October 20, 2020

Re: Application of Roseann Weeden
Borough of Belmar Board of Adjustment
P/Q: 315 Twelfth Avenue, Belmar, NJ 07719
Block 122, Lot 7, Borough of Belmar

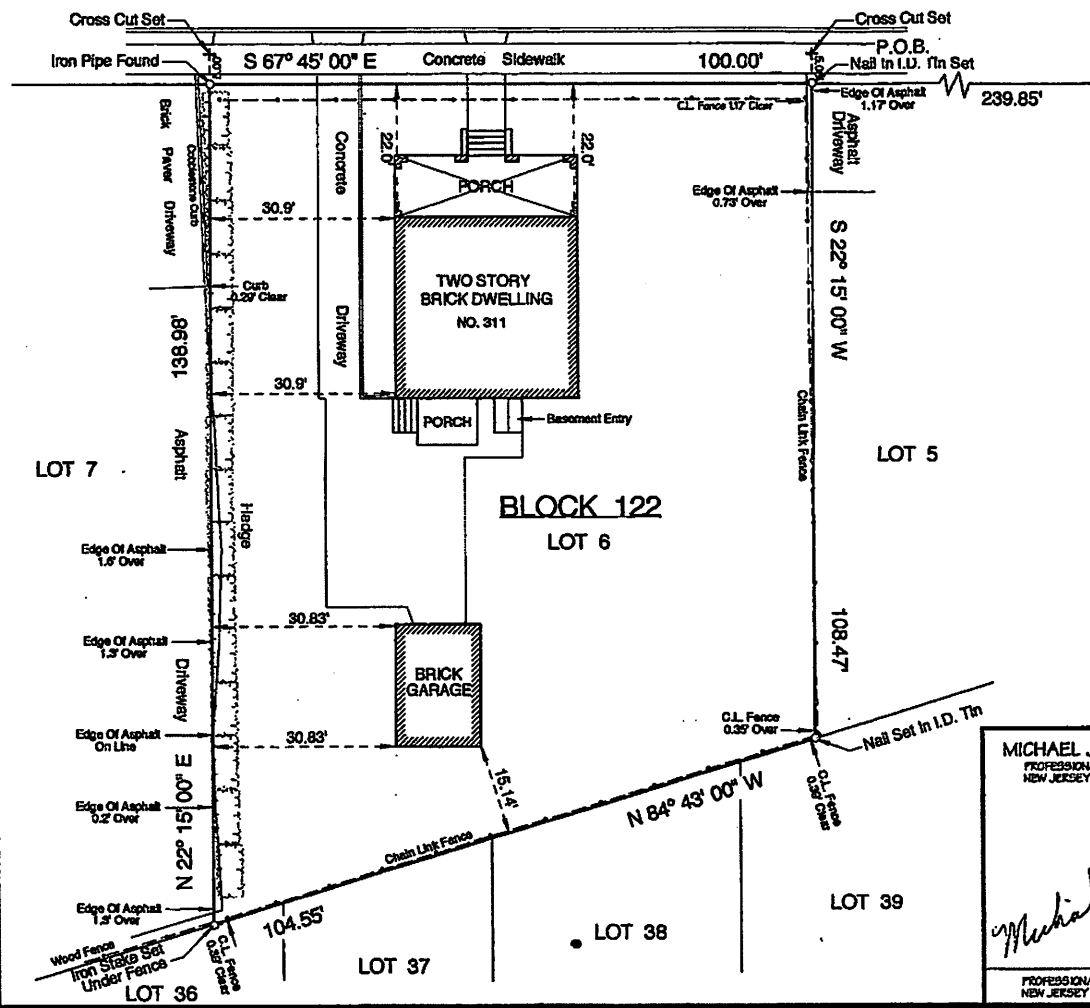
2. The application does not mention the fact that the driveway was constructed beyond the common side property line, into my client's property. At some points it is constructed over the property line by more than one foot (1'). Not only does the Applicant's survey show this, but we are also submitting my client's recent Survey, which my client will rely upon. There is a discrepancy of 0.3' in how much of an encroachment there is. Not only should that issue be rectified with the assistance of our client's respective surveyors prior to any determination made by the Board of

4. Though not referenced in the Application, a new fence was also installed at some time between June 2019 and September 2019 along the Applicant's rear property line without any Zoning Approvals. That fence was not existent and does not appear on my client's survey, but it does show on the Applicant's survey. The rear fence, as constructed, also encroaches into my client's property without authorization. The applicant should be required to submit a Zoning Permit application for the fence, and also be sure that the fence conforms and it installed solely within the Applicant's property. This should be corrected, but it too may have a similar issue related to the extent of the encroachment because of the survey discrepancies that must be resolved.
